Planning \$ 10.0	Drainage \$	BLDG PERMIT NO.	
TCP \$	School Impact \$	FILE # A.C.	
()	site plan review, multi-family dev <u>Grand Junction Commu</u>	G CLEARANCE velopment, non-residential development) NO BATHLOOT unity Development Department IN TRAILERS	
	1		
	240 NORTH ARE	TAX SCHEDULE NO	
SUBDIVISION AMEBERT LUMBUR		SQ. FT. OF EXISTING BLDG(S) <u>approx 33,020 the</u>	
ILING B	LOT	SQ. FT. OF PROPOSED BLDG(S)/ADDITONS $-\frac{160 + 9}{8 \times 90} \frac{3}{4}$	
WNER Gorda	n Harbert	MULTI-FAMILY: 71.000 NO. OF DWELLING UNITS: BEFORE AFTER AFTER	
ADDRESS		NO. OF BLDGS ON PARCEL: BEFOREAFTER CONSTRUCTION	
PPLICANT Sixby	1x Baldwin	USE OF ALL EXISTING BLDG(S) Liember your 2 hourtuin	
ADDRESS 142	O Motor ST	DESCRIPTION OF WORK & INTENDED USE: Austall	
	5 CO 8152MAY	Appyporary 2-office tracher' packing not	
	0-201-05/3	1 affactud.	
Submittal requirem	<sup>o</sup> O	ittal <b>Sug</b> dards for Improvements and Development) document.

## GRAND JUNCTION FIRE DEPARTMENT FIRE DEPARTMENT CLEARANCE FOR BUILDING PERMIT

Note: Allow a minimum of ten (10) working days for plan review					
	DATE RECEIVED: 4/30/08	TIME RECEIVED:			
PROJECT NAME: How bent Camber	PROJECT ADDRESS: 3RO J NORTH	BUILDINGU

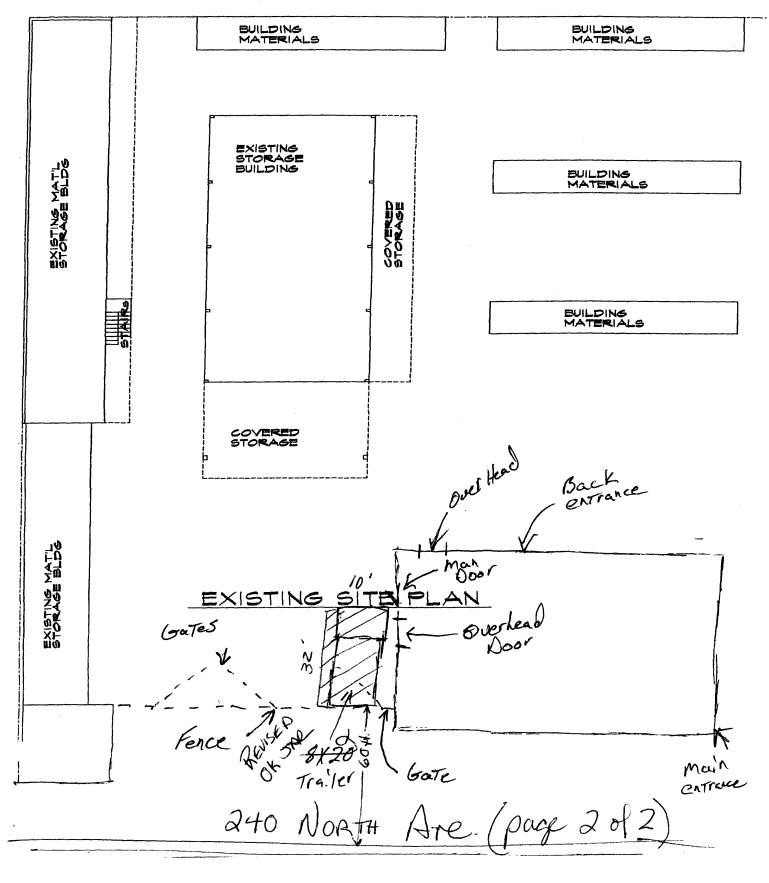
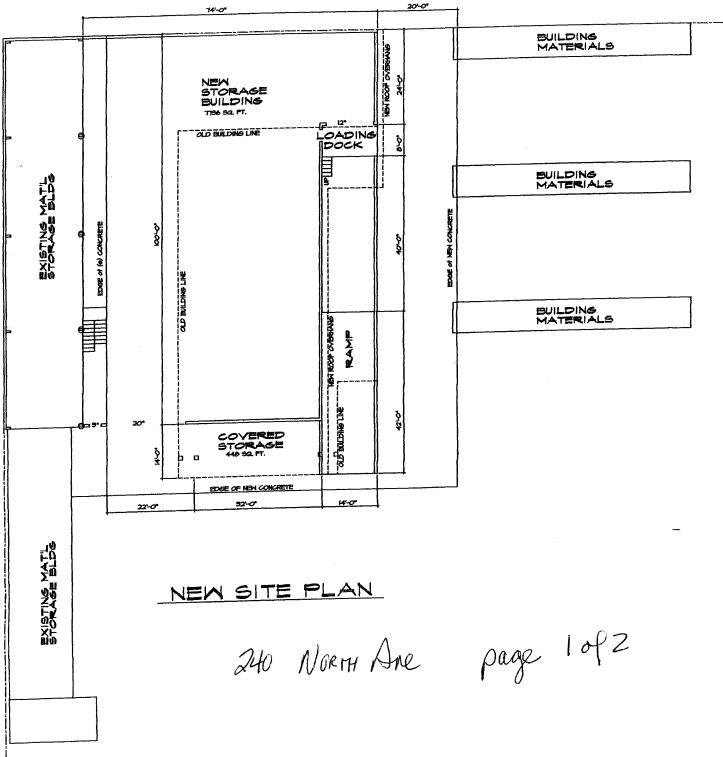
1- No Objection to temp 8x20 trailer on site for temp office. Wo five Dept requirements					
	- Lo D affice	, Wotine			
On site to	1 temp of the				
Dept refe	ivements.				
	Fire Preve	nt:on has no			
	L'IL OL	574			
Objection	av 22 The Ch	and the time			
Eize JF	miter. No tu	prother requirement			
the A					
TA-	les Mating				
1 / Mar	les MC N				
	V
